Federal Aviation Administration
Aviation Rulemaking Advisory Committee

Transport Airplane and Engine Issue Area
Loads and Dynamics Harmonization Working Group
Task 20 – Ground Handling Conditions

Task Assignment

Aviation Rulemaking Advisory Committee Transport Airplanes and Engine Issues--New Tasks

FIGURE 9 – Convex Runway Profile

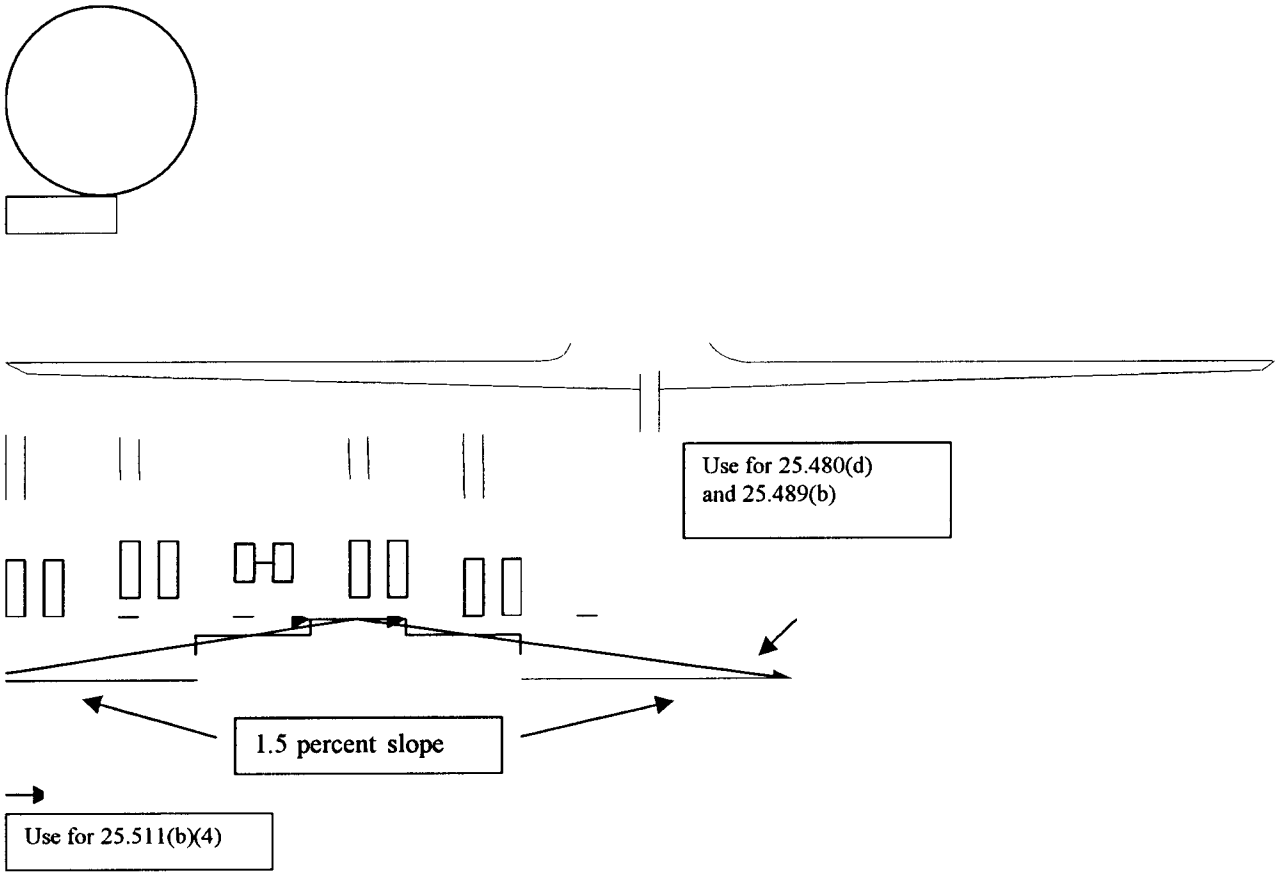
- For airplanes with more than two main landing gear units, a convex runway shape must be considered. A new figure (Figure 9) is added to Appendix A to depict this runway profile, and is also

referenced by Secs. 25.489 and 25.511. This figure is shown on the last page of this document.

- Paragraph (a) is reorganized for clarity.
- "No wing lift may be considered" is changed to "The airplane lift must be assumed to be zero" for clarity.
- Paragraph (b) is added to address airplanes with more than two main landing gear units. For these airplanes, a convex runway shape must be considered. A new figure (Figure 9) is added to Appendix A to depict this runway profile.

- Paragraph (d) is revised with regard to references to Sec. 25.485, which has been reorganized. The revised paragraph (d) is equivalent to the existing requirements.
- Paragraph (e)(4) is revised to indicate that Sec. 25.493(c) and (d) are not considered with deflated tires. This was specified in the JAR 25.493 at Change 14, but when the new harmonized criteria was developed, this provision was mistakenly deleted from both the JAR at Change 15, and the new FAR 25.493 at Amendment 97.
- Paragraph (b)(4) is revised to provide a reference to the new figure 9 of Appendix A.

For Sections 25.480(d) and 25.489(b), use "stepped" runway to approximate convex runway with 1.5 percent slope.

For Section 25.511(b)(4), use actual slope as shown.
